UNITED STATES PATENT AND TRADEMARK OFFICE

APPLICATION NO.	FILING DATE	FIRST NAMED INVENTOR	ATTORNEY DOCKET NO.	CONFIRMATION NO.
10/707,583	12/22/2003	THOMAS D. WILLIAMS	33610	1582
23589	7590	11/16/2005	EXAMINER	
HOVEY WILLIAMS LLP 2405 GRAND BLVD., SUITE 400 KANSAS CITY, MO 64108			WOLFE, DEBRA M	
			ART UNIT	PAPER NUMBER
			3725

Office Action Summary	Application No.		Applicant(s)	
	10/707,583		WILLIAMS, THOMAS D.	
	Examiner		Art Unit	
	Debra Wolfe		3725

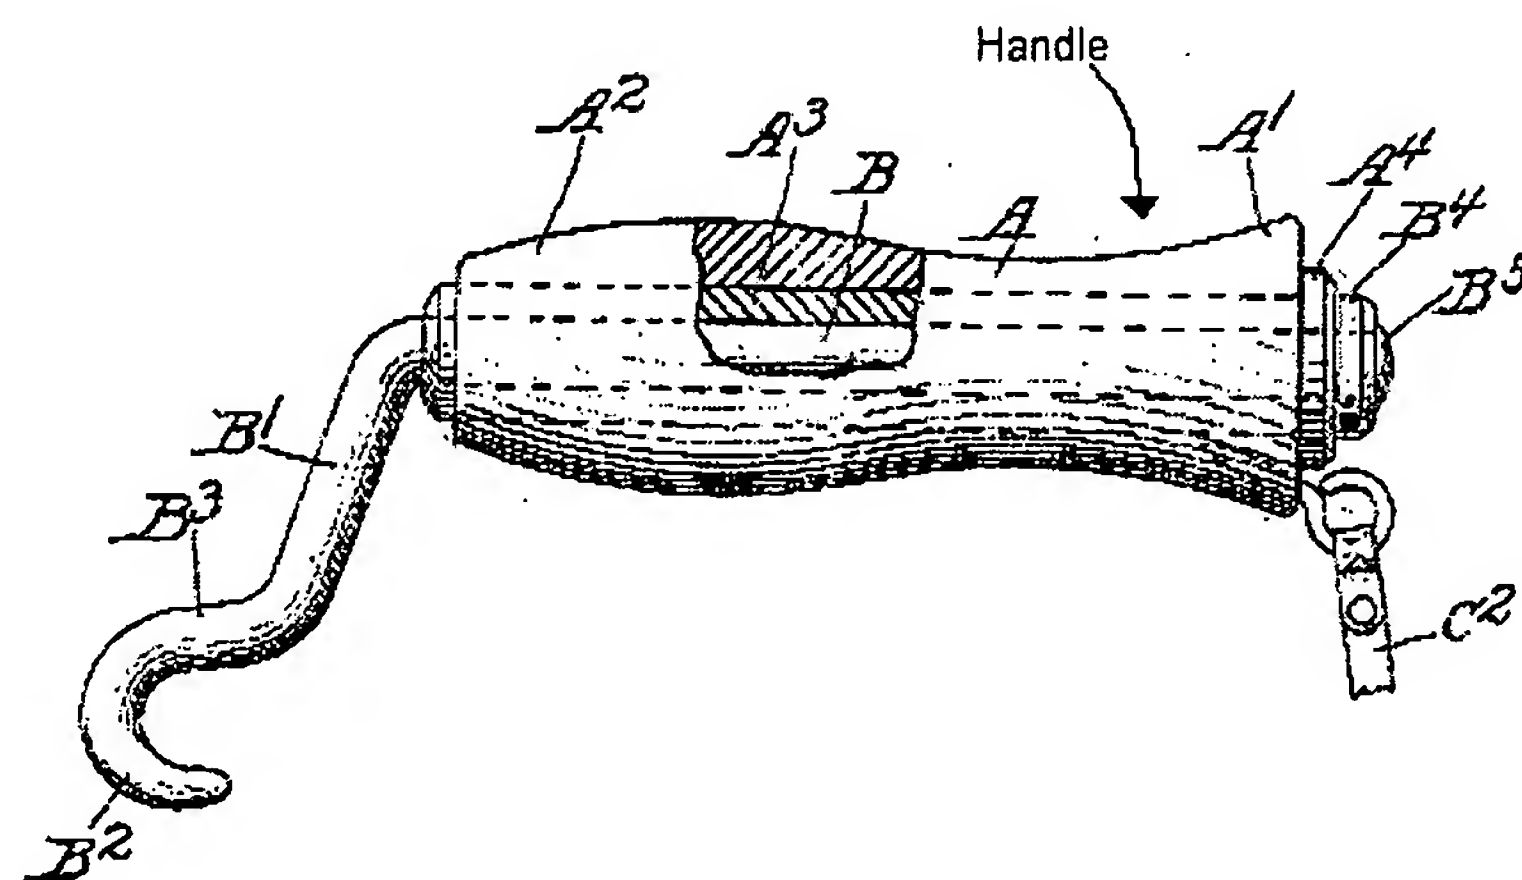
1. Claims 1-5, 8, 10, 13, 14 are rejected under 35 U.S.C. 102(b) as being anticipated by Bates (U.S. Patent # 1,365,649). Bates discloses a wire tying tool having an elongated rod (crank arm B') with opposite spaced apart ends and an arcuate clip engaging portion (bight B^3) for securing a clip device (C') through a bending motion; and a wooden handle (See FIG below), that is angularly projecting from one end of the rod and is generally transverse and projecting generally perpendicularly thereby presenting an approximately 90° angle relative to the rod. Bates also discloses the handle having a rotatable handle cover (metallic sleeve A^3 , and handle A) that is supported by a center shaft (shank B) having opposite spaced apart handle ends wherein one handle end is adjacent to the rod. The center shaft (shank B) and rod (crank arm B') of Bates

is integrally formed to cooperatively present a bent unitary bar (center dotted line within handle, See FIG 1).

FIG. 1

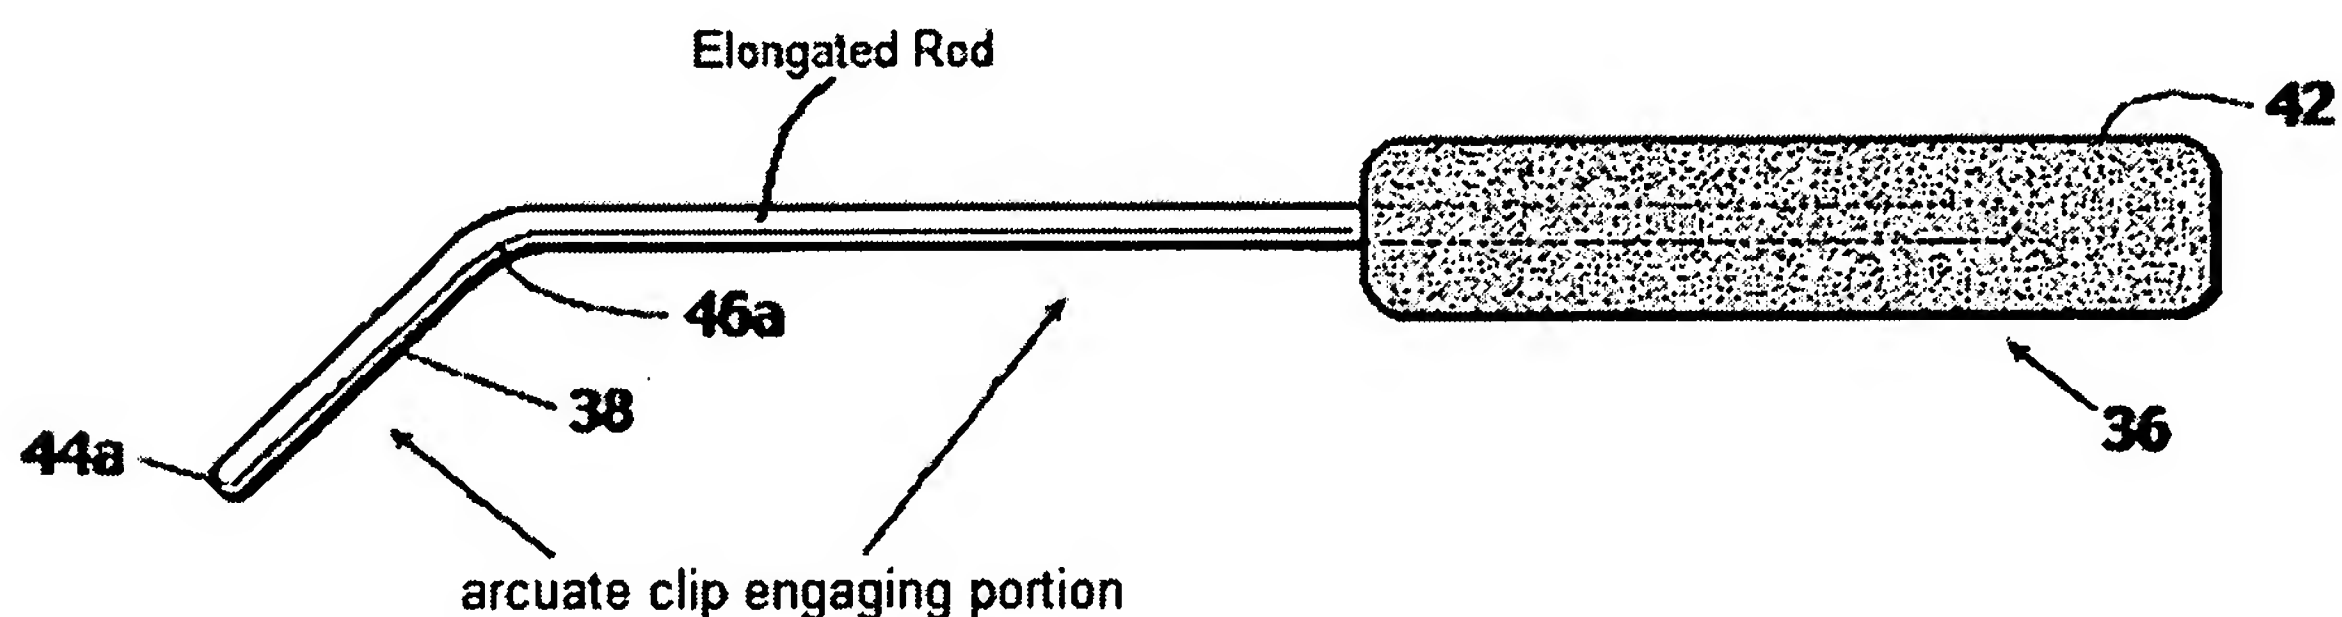
1. Claims 1-17, 19-34 are rejected under 35 U.S.C. 103(a) as being unpatentable over Hodge, Sr (U.S. Patent # 6,499,514) in view of Bates (U.S. Patent # 1,365,649), Eastman Kodak, The Federal Aviation Administration (FAA) and Official Notice. Hodge, Sr discloses a fencing tool having an elongated rod (See FIG 1 below) presenting opposite spaced apart ends and is configured to engage a clip (20) with the arcuate clip engaging portion (See FIG 1 below) between the ends for securement of a fencing wire (fence wire 50) through a bending motion; a handle (42) angularly projecting from one end of the rod and is generally transverse and projecting generally perpendicularly thereby presenting an approximately 90° angle relative to the rod. The handle of Hodge, Sr includes a center shaft (dotted lines within handle, See FIG 4) having opposite spaced apart handle ends wherein one handle end is adjacent to the rod, it is also

disclosed that the center shaft and rod are integrally formed to cooperatively present a bent unitary bar (See FIG 4). Hodge, Sr discloses the invention substantially as claimed except for wherein the handle includes a rotatable handle cover and an end cap. However, Bates discloses a wire tying tool with a handle (See FIG 2 below) having a rotatable wooden or fiber handle cover (metallic sleeve A^3 , and handle A) that is supported by a center shaft (shank B) and an end cap (upset B^5) removably attached to the handle end opposite from one of the handle ends (examiner interprets "removable" in the broadest sense) and is configured to cooperatively retain the handle cover (metallic sleeve A^3 , and handle A) on the center shaft (shank B). Therefore it would have been obvious to one of ordinary skill in the art to utilize the crank-like rotatable sleeve handle and end cap (upset B^5) of Bates with the fence clip tool as disclosed by Hodge, Sr since such a modification would allow for an improved form of a hand operated, hand controlled wire tying tool and prevent movement of the handle cover upon the center shaft.

Figure 5 of Hodge, Sr shows the rod length to be approximately equal to five inches and further shows the arcuate clip-engaging portion (See FIG 1 below) having an arc-length not less than about seventy-five percent of the rod length. Furthermore, a change in size to the rod length or arc-length of the arcuate clip engaging portion would have been obvious to one of ordinary skill in the art at the time the invention was made in order to better enable use of the tool by the user. Let it be noted that the specification does not disclose any criticality to the length of the rods (See paragraph 22 lines 8-11 and paragraph 23 lines 13-16) claimed and therefore the examiner reasserts the above position.

FIG. 2

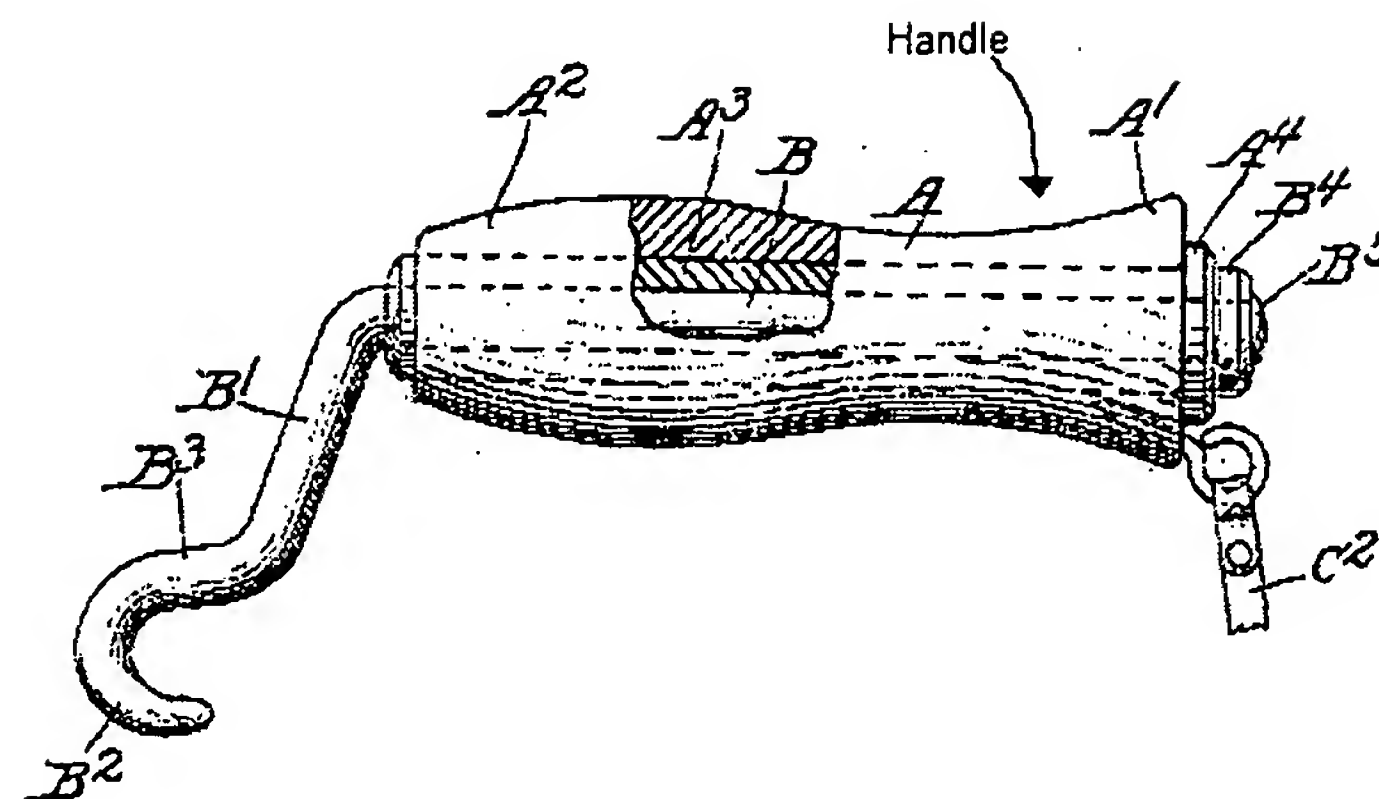
2. Claims 19-22, 25, 27, 30, and 31 rejected under 35 U.S.C. 102(b) as being anticipated by Bates (U.S. Patent # 1,365,649). Bates discloses a wire tying tool having an elongated rod (See FIG below), that is angularly projecting from a handle, (See FIG below) with opposite spaced apart ends and an arcuate clip engaging portion (bight B^3) for securing a clip device (C^1) through a bending motion; and a wooden handle (See FIG below), that is projecting from one end of the rod and is generally transverse and projecting generally perpendicularly thereby presenting an approximately 90° angle relative to the rod. Bates also discloses the handle having a rotatable handle cover (metallic sleeve A^3 , and handle A), that is supported by and rotatable relative to the center shaft (shank B), having opposite spaced apart handle ends wherein one handle end is adjacent to the rod. The center shaft (shank B) and rod (See FIG below) of Bates is integrally formed to cooperatively present a bent unitary bar (center dotted line within handle, See FIG 1).
